AGENDA OF THE LANDMARKS COMMISSION

WEDNESDAY, FEBRUARY 19, 2025, 4:30 PM
City Hall, Room 604 - The Harry Maier Room.
Virtual attendance is also available via Zoom.

Report to the
Landmarks Commission
of the City of Green Bay

(COA 25-01) Consideration with possible action on a design review for a cell tower at 1424 Admiral Court.

1 WEST ELEVATION
3/8" = 1'-0"

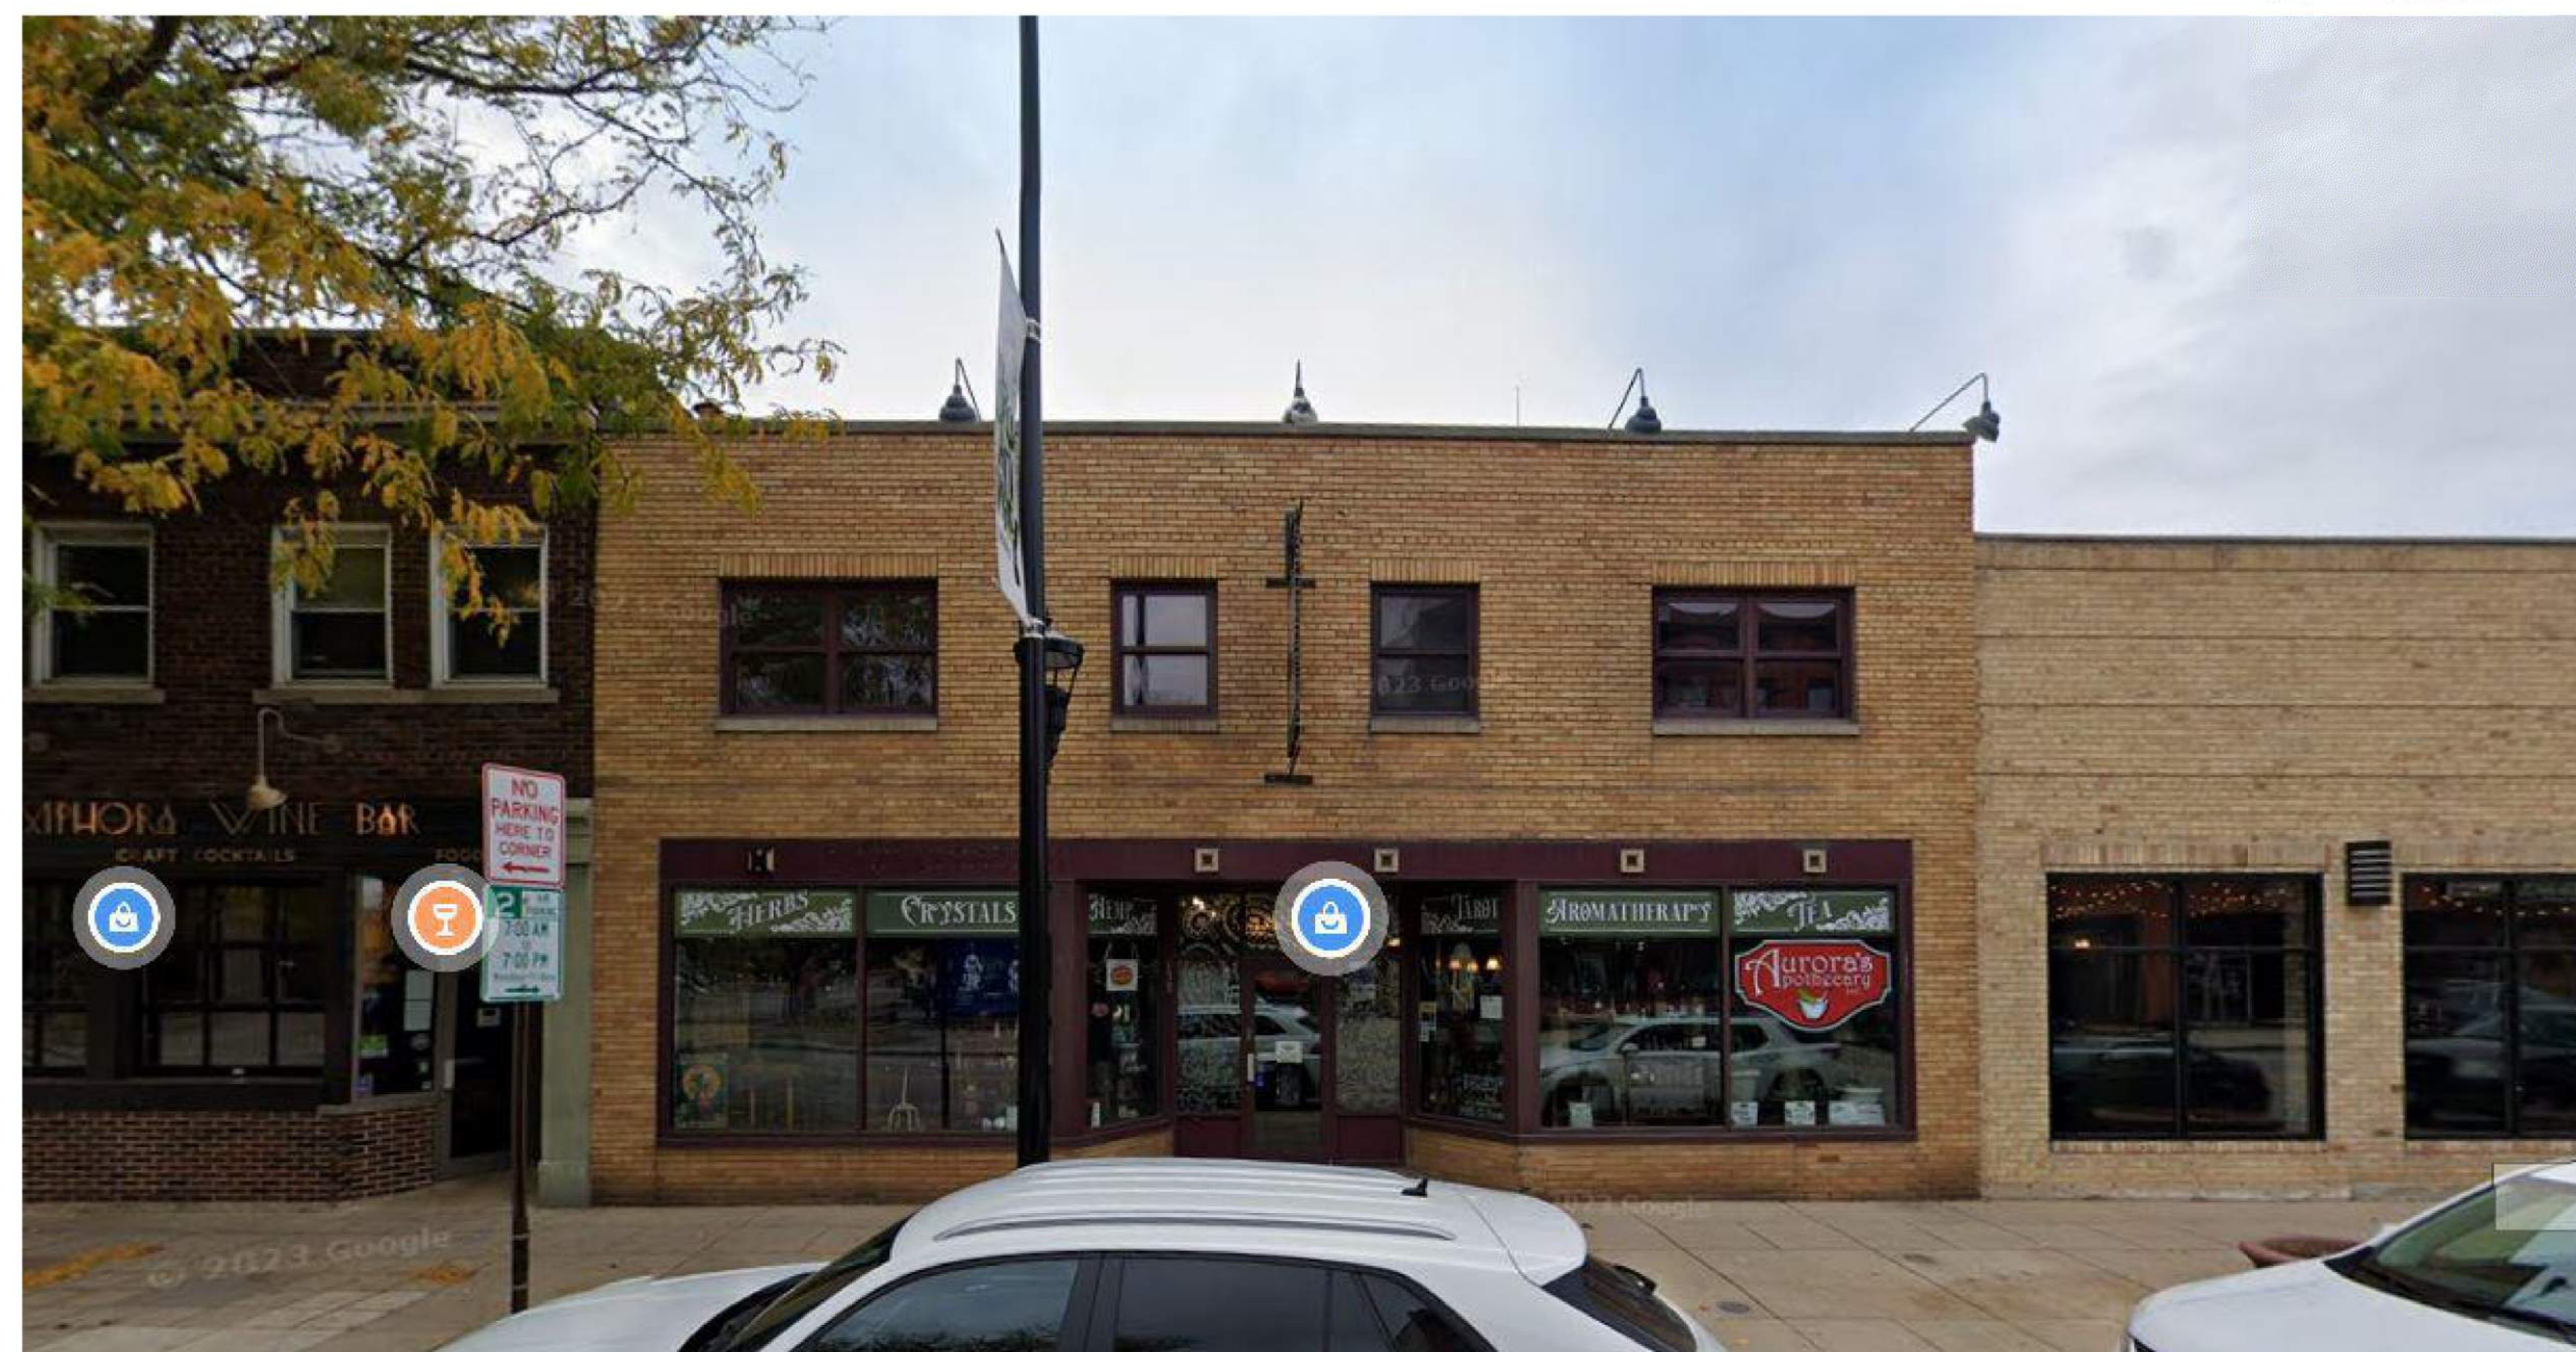
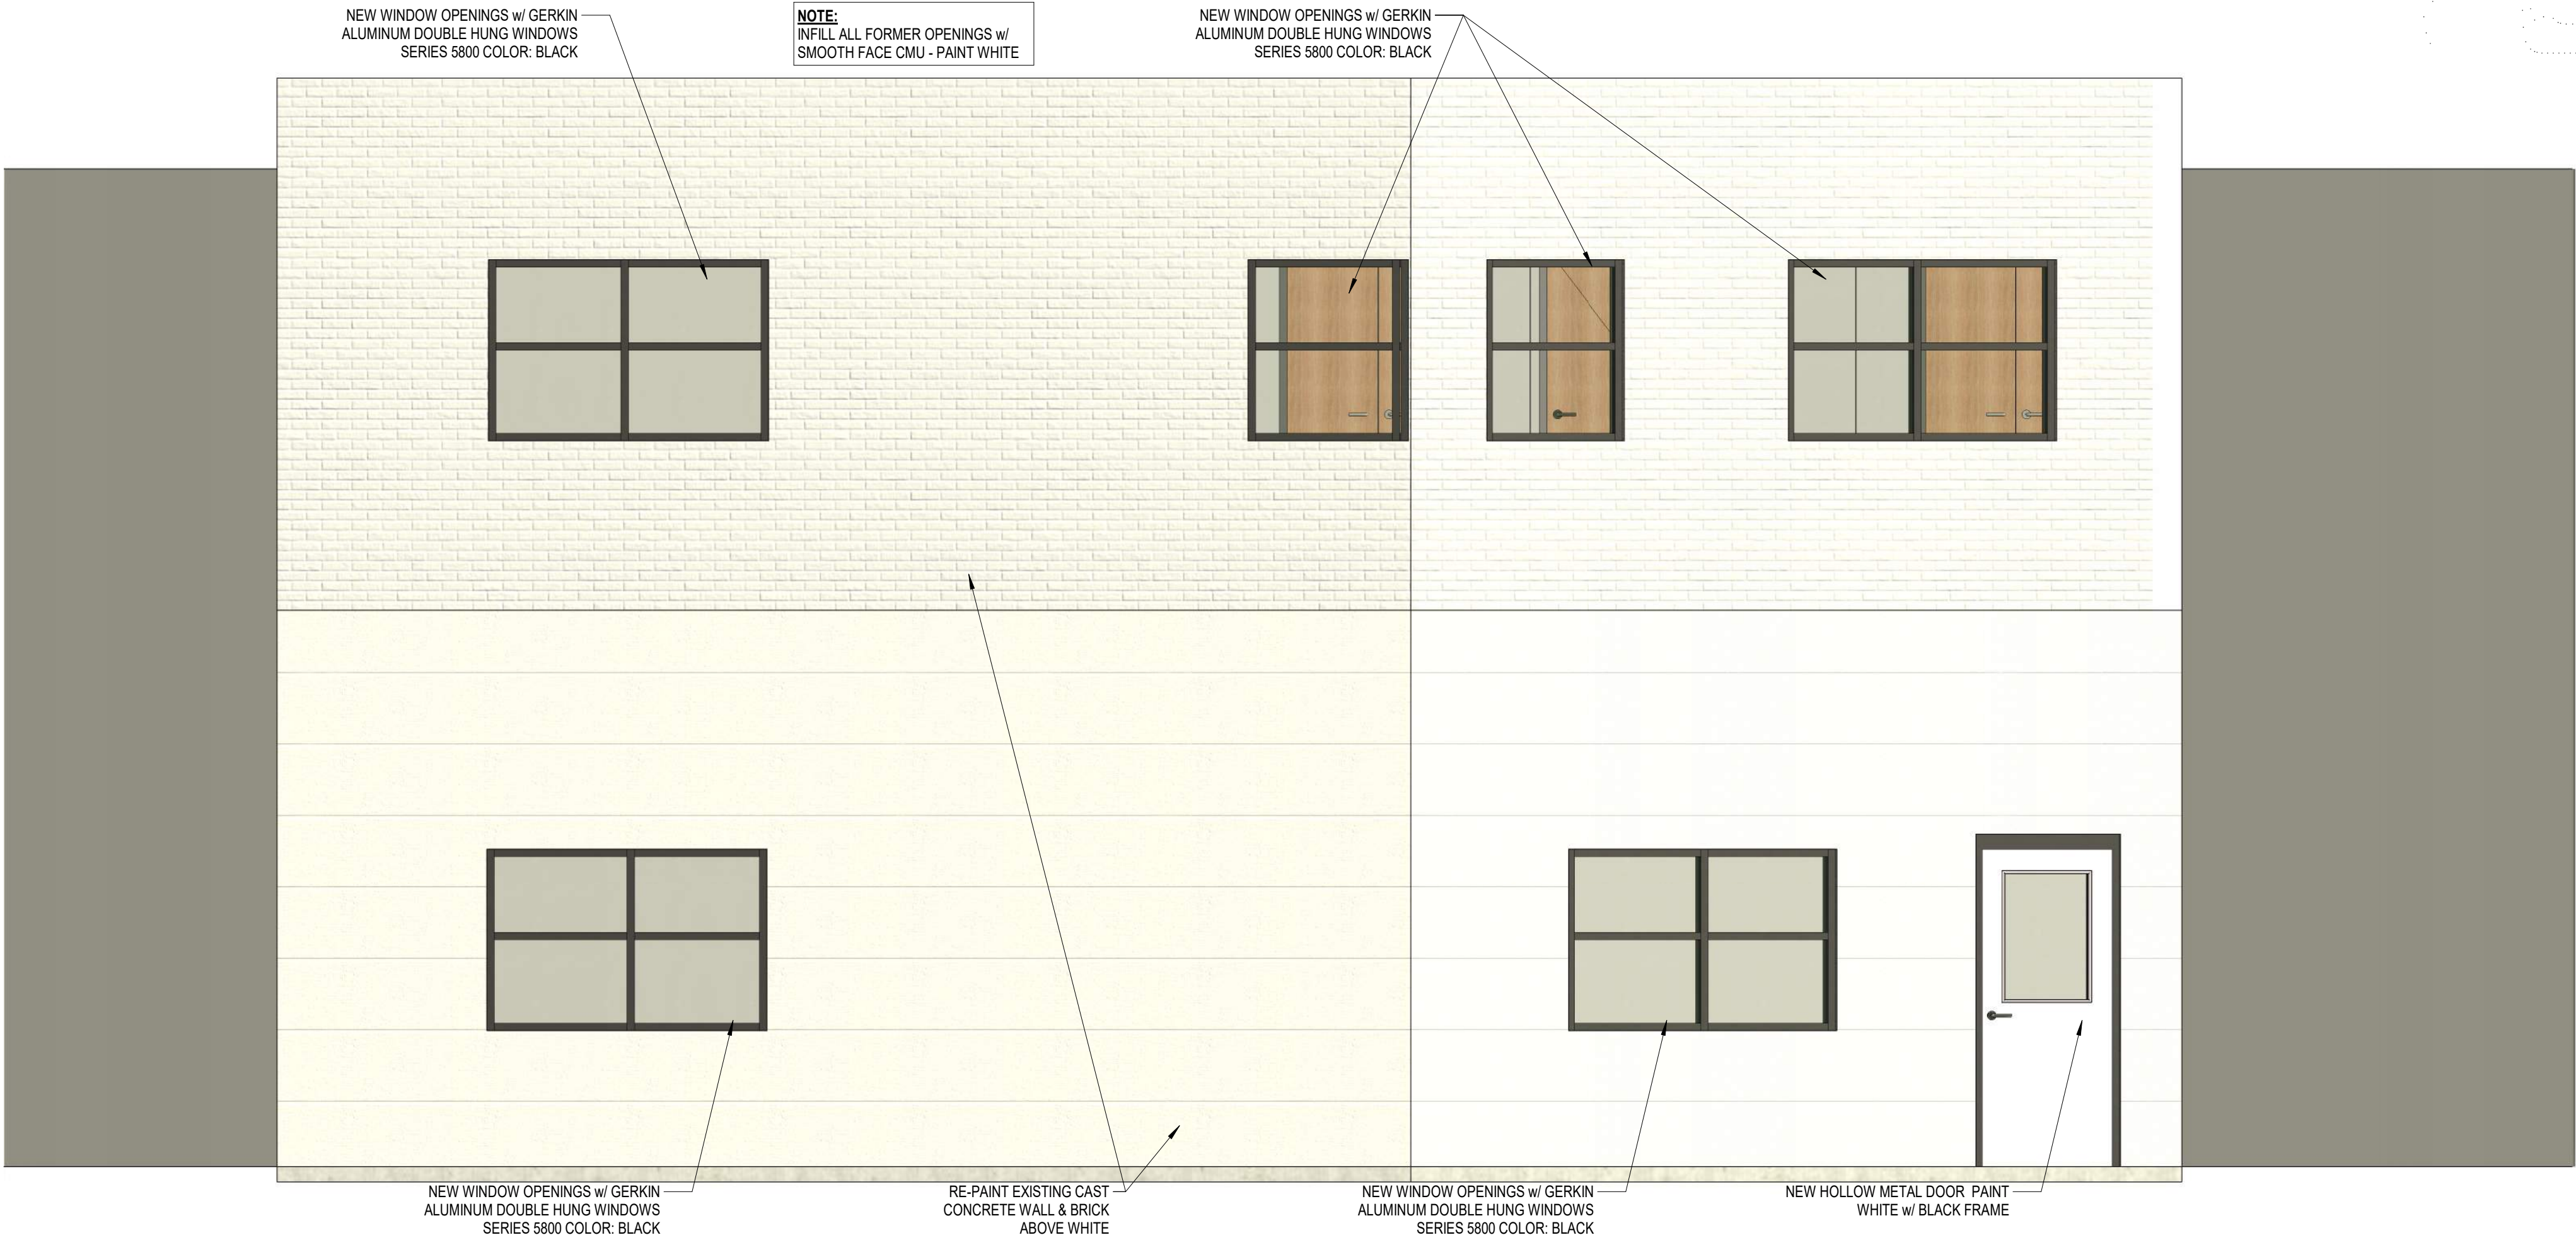
Storefront – The existing storefront matches that present at time of NRHP listing in 1999 and that shown in a 1986 photograph – a symmetric façade with recessed doorway at center. No historical images have been provided (ref. SOI # 6). The proposed alteration calls for a new recessed entrance to be added north of the existing doorway. This new recessed entrance, as proposed, does not appear to have a comparable precedent on this building and will have a significant impact on the appearance of the building (ref. SOI # 2) and does not mimic the design of secondary entrances elsewhere in the district (the surrounding streetscape). Alternative designs appear to be possible that could eliminate or minimize the visual impact of introducing a second door on the storefront.

LC staff notes that the proposed changes to the rear elevation will have a minimal impact to the historic integrity of the building and the district. LC staff notes that window and door frames should have a painted or powder coat finish (not anodized).
